# PEER REVIEW CONCEPT

# Peer Review Concept Design

# Peer Review Concept Design

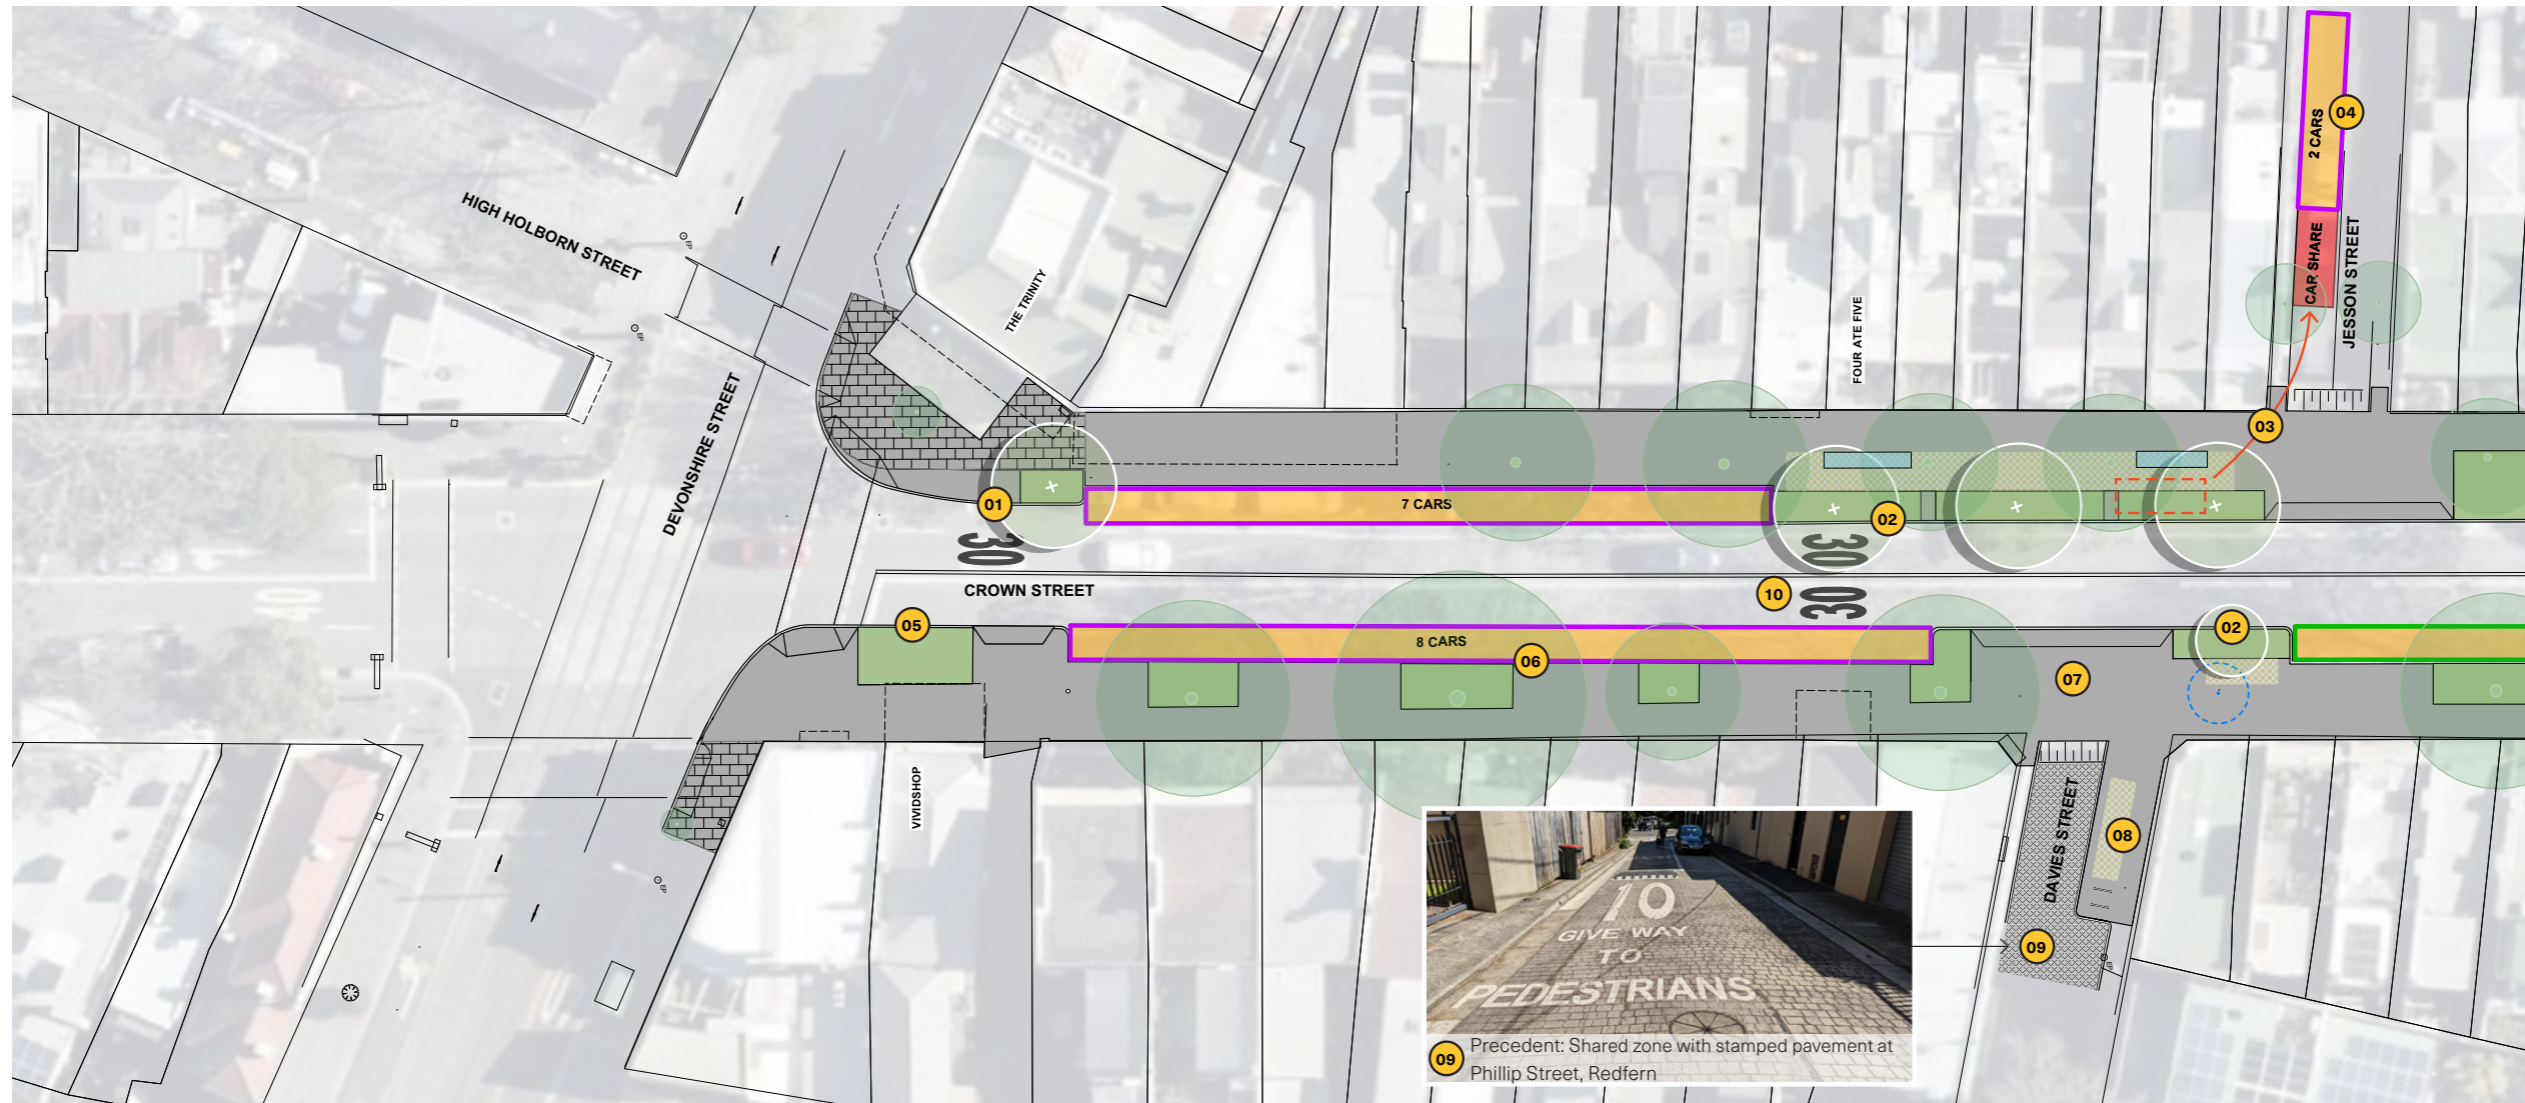
1. Kerb extension and new street tree as per AECOM concept design.
2. New kerb extension to create activation area with kerbside planting and additional street trees at existing commercial premises.

3. Relocate 1 no. existing car share parking space to Jesson St.
4. Convert 2-3 no. existing unmarked 2P parking spaces on Jesson St to 2 no. marked 2P parking spaces.

5. Kerb extension to provide additional pedestrian paving and planting at intersection, with operations to intersection to remain unchanged (subject to TfNSW approval).

6. Kerb alignment adjusted (to minimum compliant parking space width) to maximise footpath and planting space. Increased planting beds to base of existing trees.

7. Continuous footpath treatment and kerb extension at Davies St.
8. Kerb extension to Davies St to provide additional activation area and space for new bike parking.

9. New shared zone with stamped pavement to Davies St, to be consistent with other typical City of Sydney laneway shared zones (subject to further investigation and TfNSW approval).

10. Speed reduction to Crown Street to 30km/h (subject to TfNSW approval).
